CITY PLANNING COMMISSION

- APPLICATION:
1. Negative Declaration
 2. Development Plan Review of 134-unit apartment complex on 6.4± acres in the R-2B-R zone (13-A-3-C-4) (P84-113)

LOCATION: Northwest corner of Rush River Drive and Windbridge Drive

RUSH RIVER APARTMENTS

site plan

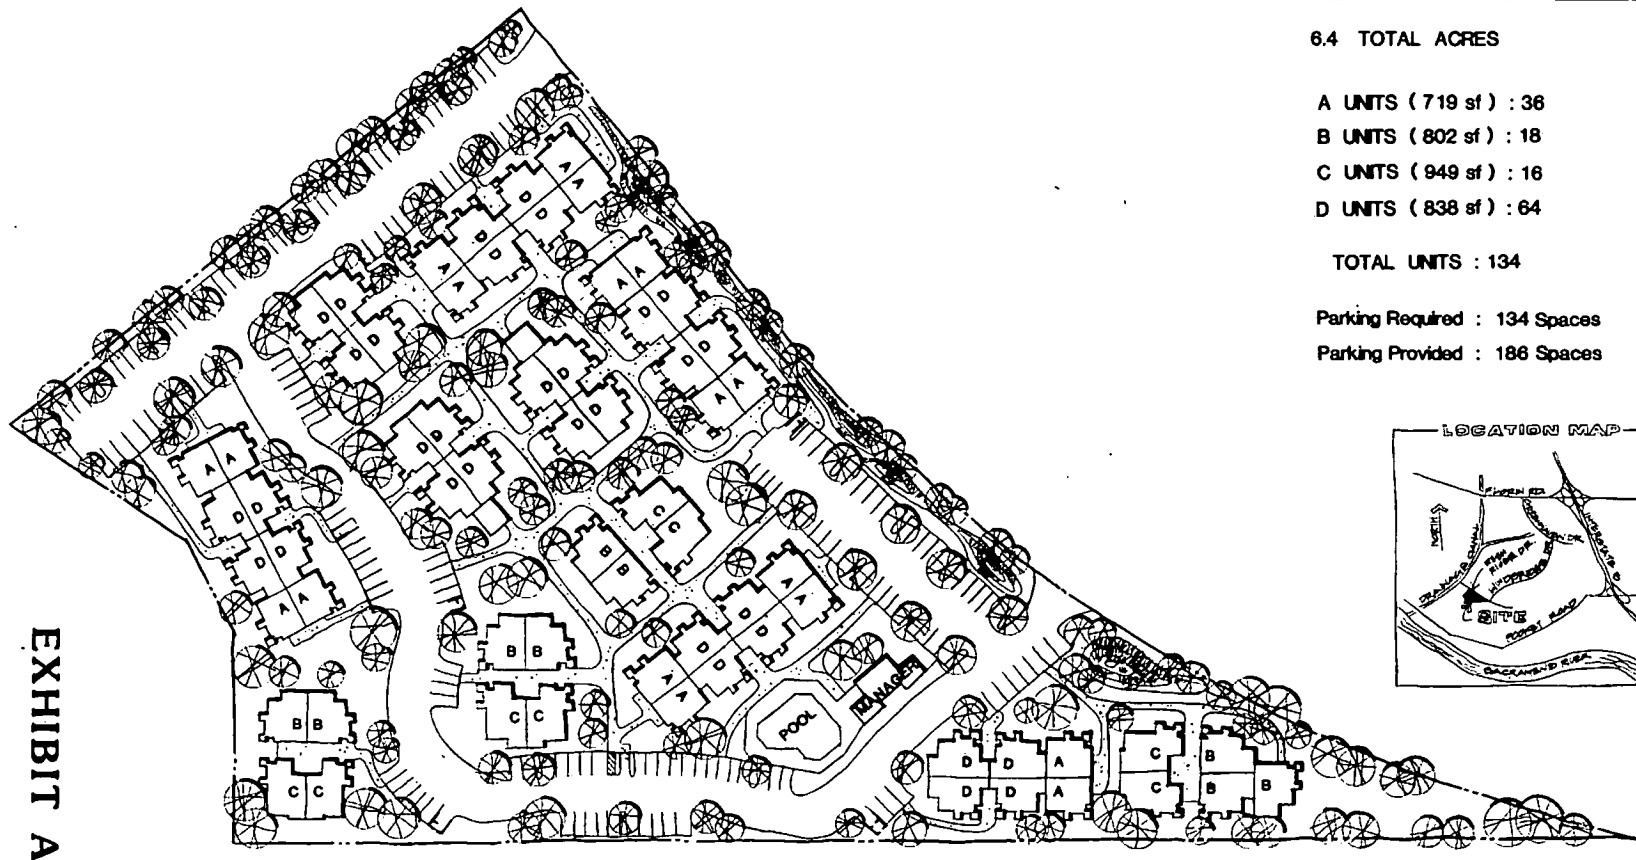
1. The site plan indicates a cluster of units that will be located along the westerly boundary of the site adjacent to future single family units. These units are approximately 20 feet from the property line. In order to reduce overview of the second story apartment units into the rear yards of abutting residences, staff suggests that the setback be increased to a minimum of 25 feet.

In addition, staff suggests intense landscaping be provided along the westerly property line.

2. Parking is to be provided along the northwesterly property line. Intense landscaping is also appropriate as a buffer between the apartment parking and the rear yards of zero lot line residences.
3. The site plan does not provide dimensioning of setbacks, parking spaces, distances between buildings, etc. There are no apparent problems; however, the project will be reviewed on the more detailed plan to be submitted at the time of building permit application. Compliance with the Zoning Ordinance, Building Codes, and the attached Multiple Family Design Criteria (see Exhibit C) will be required at that time.

1. Increased setback of structures along the southwest property line to a minimum of 25 feet;
2. Intense landscaping along the westerly and northwest property lines for purposes of visual and noise buffering shall be provided;
3. Compliance with the Multiple Family Design Criteria;
4. A detailed landscaping and irrigation plan shall be submitted for staff review and approval prior to issuance of any building permit.
